SERVICE BULLETIN

from: TRIO-KENWOOD COMMUNICATIONS, INC.

TS-830S

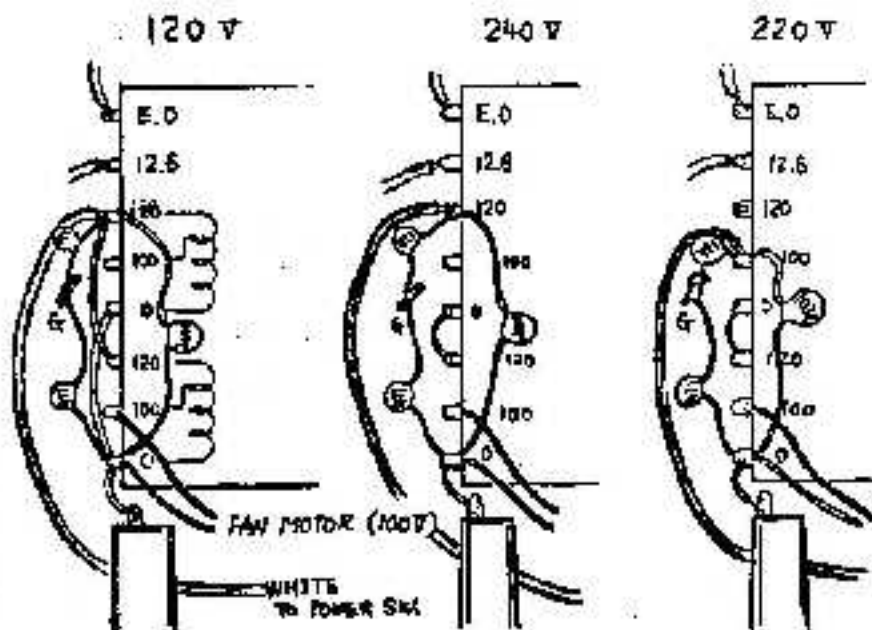
To operate the TS-830S on 240V AC, the power transformer split primaries must be rewired from parallel to series connection.

1. Unplug the AC power cable.
2. Remove the bottom cover.
3. Remove the jumper wires between the two ϕ terminals and two 120 terminals on the bottom of the power transformer.
4. Connect the adjacent 120 and ϕ terminals at the middle of the transformer. This will provide 240V AC operation.
For 220V A. operation, connect the adjacent 100 to ϕ winding.
5. Change the AC fuse from 6A to 4A. Tag the power cord at the back of the radio to indicate that the transformer is strapped for 240V AC, and the power fuse should be 4A, and not 6A.
6. Replace the bottom cover and reconnect power to verify your work.

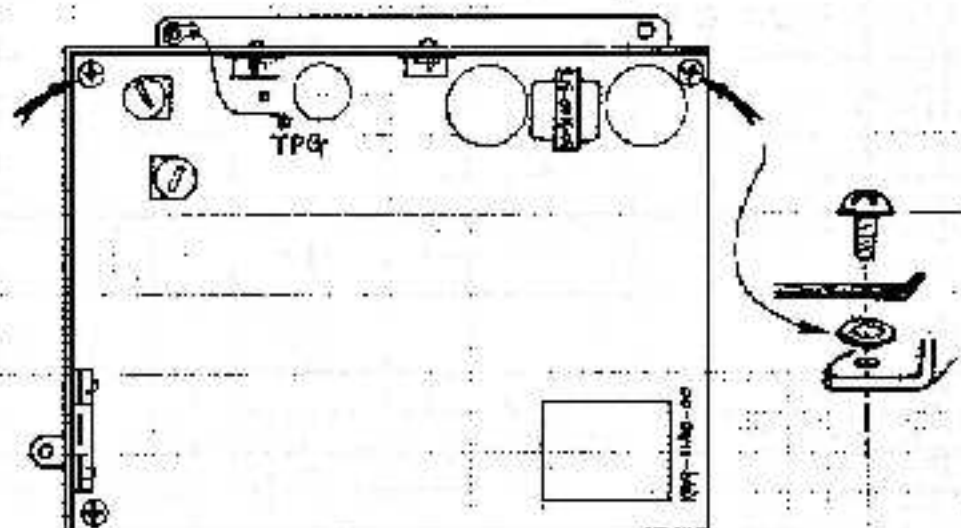
Some users may report an intermittent shift in display and operating frequency. This may typically be a 1 to 4 KHz random shift. Cause will be a loose grounding screw on the AF-AVR unit heat sink.

On the AF-AVR unit X49-1140-00, there are three self-tapping screws holding the aluminum heat sink to the PCB. These also supply the ground connection to that section of the board. Between the heat sink and PCB foil, add a tooth-lock washer N17-1030-41 at the two self-tapping screws shown. (The remaining screw already has a tooth-lock washer.) When replacing the board to the chassis, add a solder lug E23-0420-05 to the heat sink mounting screw as shown, and tighten all screws for this board. Solder an insulated lead between the TPG (Test Point Ground) wrap post adjacent to C81, and the added solder lug.

1. Remove the top cover (8 screws) and unplug the speaker.
2. Remove the bottom cover (8 screws).
3. Remove 5 screws holding the AF-AVR unit and swing the board over. Leads do not have to be unplugged.
4. Add two tooth-lock washers as shown.
5. Replace the circuit board and heat sink to the chassis, adding the solder lug as shown.
6. Solder a jumper between the TPG wrap post and the added solder lug.
7. Replace the top and bottom covers.

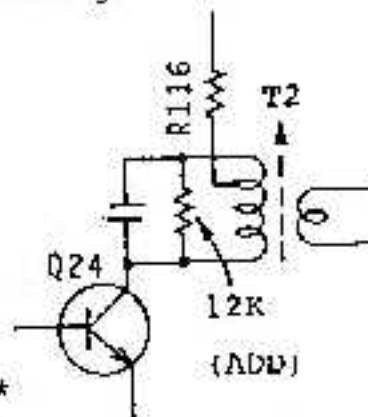
At the Noise Blanker level control VR8, change R19 from 22 Ω to 15 Ω (RD14BE2E150J)*

AF UNIT X49-1140-00

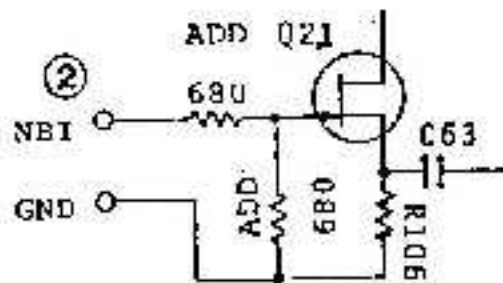
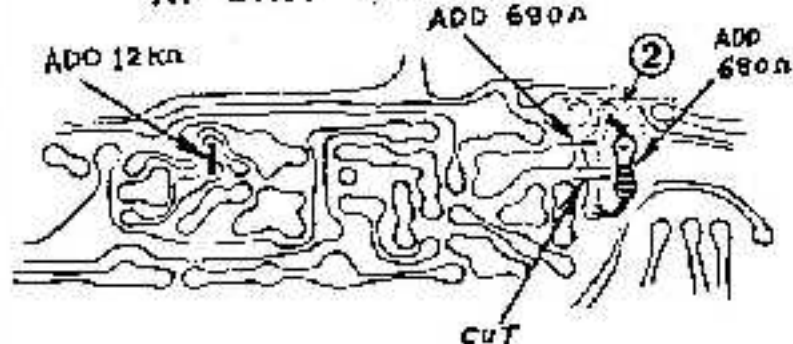
Across T2, (Fig. 1) add a 12K Ω (RD14CB2E123J)*

At Q21 (Fig. 2,3) add 2 pcs. 680 Ω (RD14CB2E681J)*

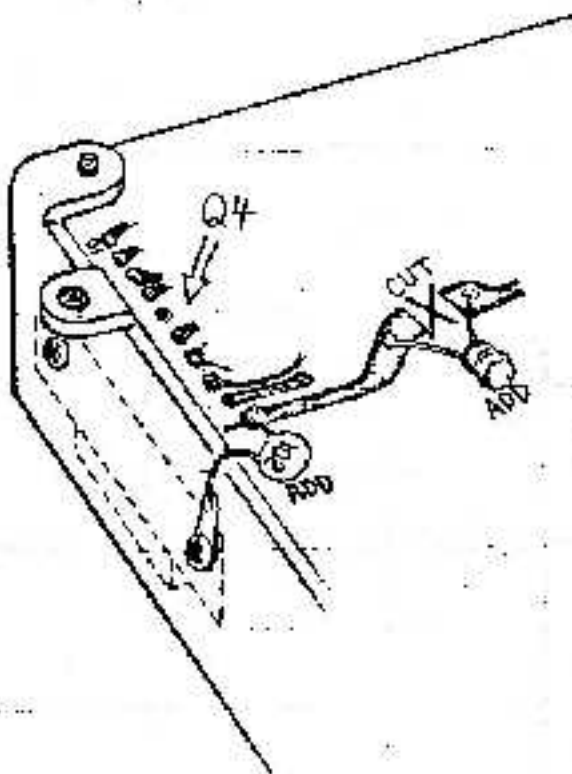
Transmitter "talkback", either with or without a linear amplifier, may be eliminated by adding a filter at the receiver audio power amplifier.

On the AF unit X49-1140-00 at Q4, cut the 12V DC B+ line between R47 and C28, and add a 1 μ h choke (L40-1092-02) in-line. Add a .01 μ F cap (C52-1710-36) from the 1C pin 1 to ground, as shown using a 3mm lug (E23-0015-04) under the IC mounting screw on the Heat Sink.
